Subject: SQUEAKING NOISE FROM REAR OF VEHICLE WHEN DRIVING ON BUMPY ROADS AND TURNING	Bulletin No.: 02-001/24
	Last Issued : 01/30/2024

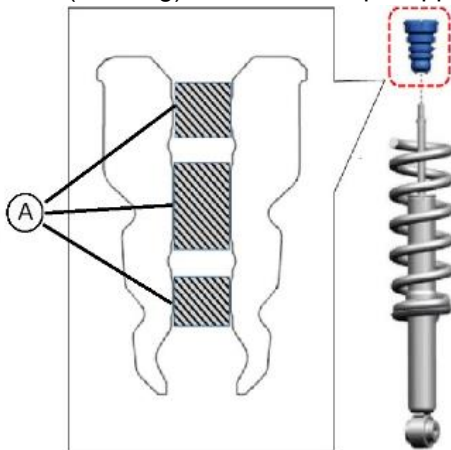
Some customers may complain about squeaking noise coming from the rear of vehicle when driving on bumpy roads and turning. This is caused when the lubricant coating comes out of the bump stopper, changing the resistance between the damper rod and bump stopper. To eliminate this concern, **rubber grease is being added inside the bump stoppers during the production process.**

1. Verify the customer concern.
2. Remove both rear bump stoppers according to the instructions in MGSSI (REAR SHOCK ABSORBER AND COIL SPRING REMOVAL/INSTALLATION) and (REAR SHOCK ABSORBER AND COIL SPRING DISASSEMBLY/ ASSEMBLY).
3. Apply rubber grease (0.5-1.0g) inside the bump stopper, principally at the areas indicated in the image below (A).
